1600 SOUTH OCEAN BOULEVARD

SUMMARY OF CHANGES

Z-19-00200
B-037-2019 1600 SOUTH OCEAN
PALM BEACH, FLORIDA

CURRENTLY PROPOSED EAST ELEVATION

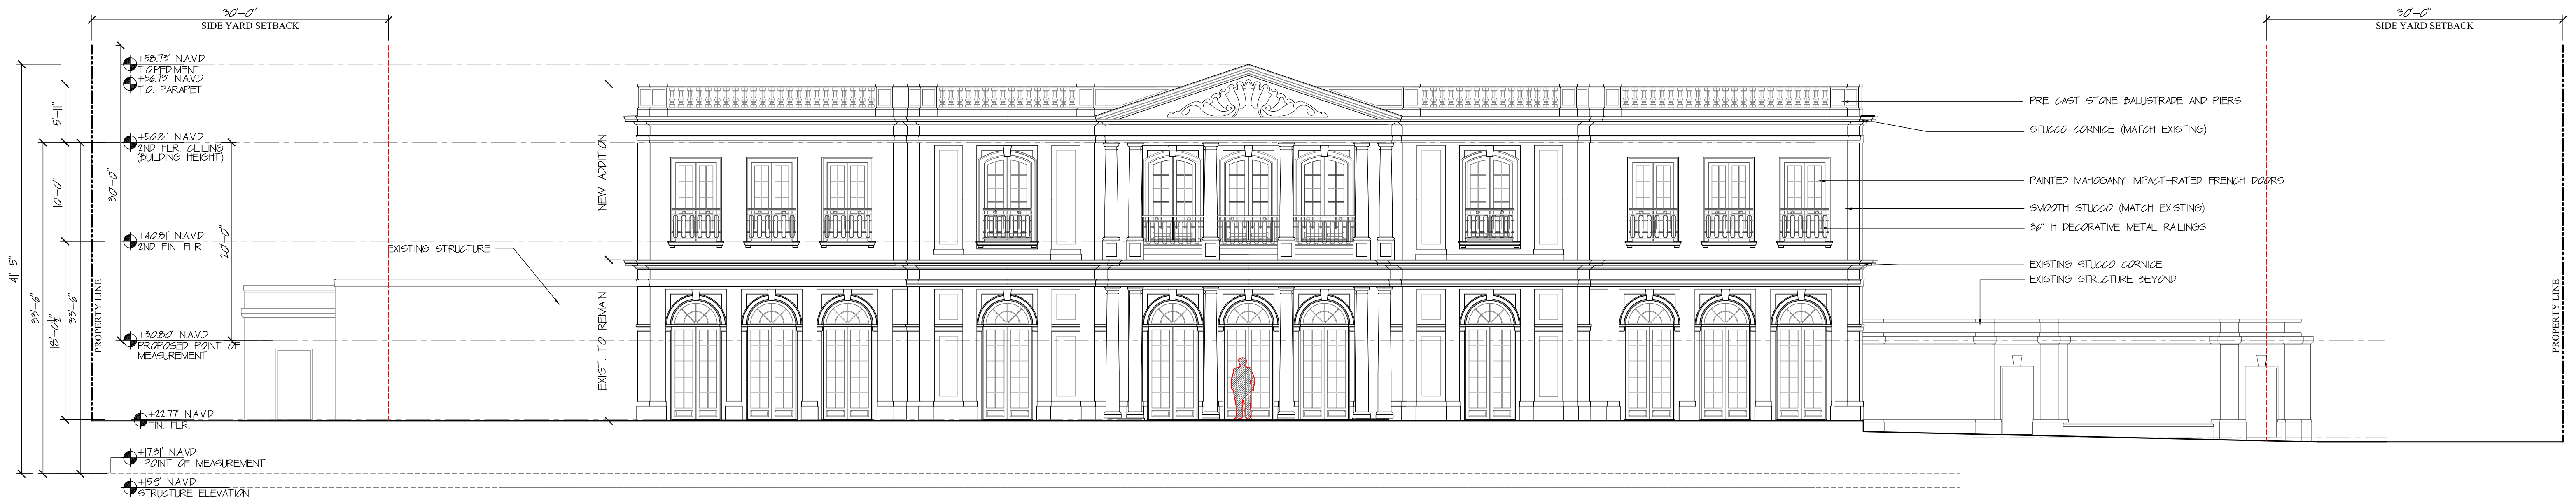
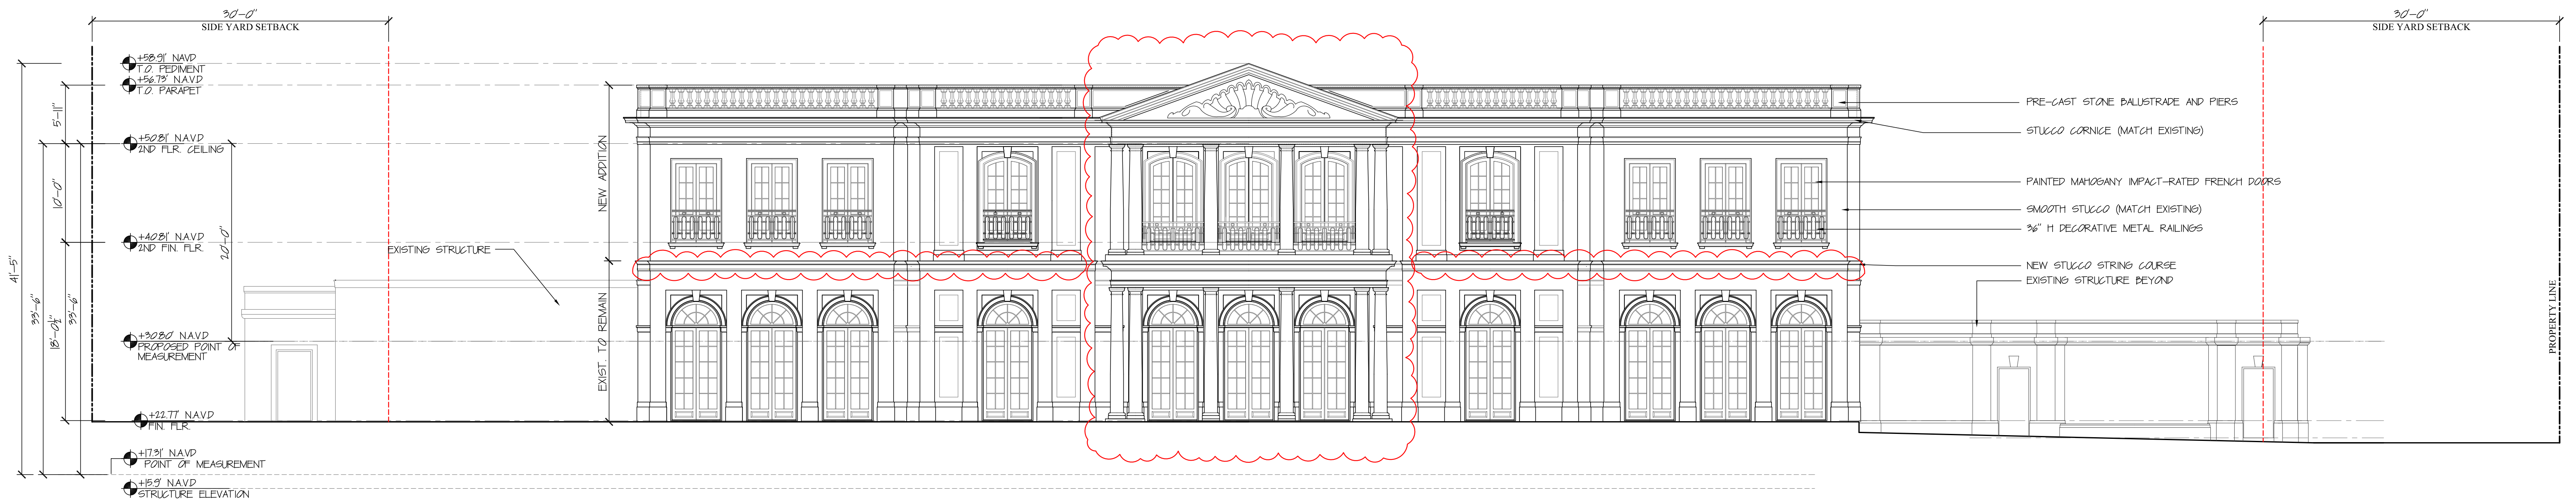
1. Adjusted east wall to receive Architrave.
2. Adjusted spacing of paired columns on east elevation.
3. Simplified string course.
4. Added coconut palms to landscape plan.
5. Removed rustication at basement level doors on West elevation.
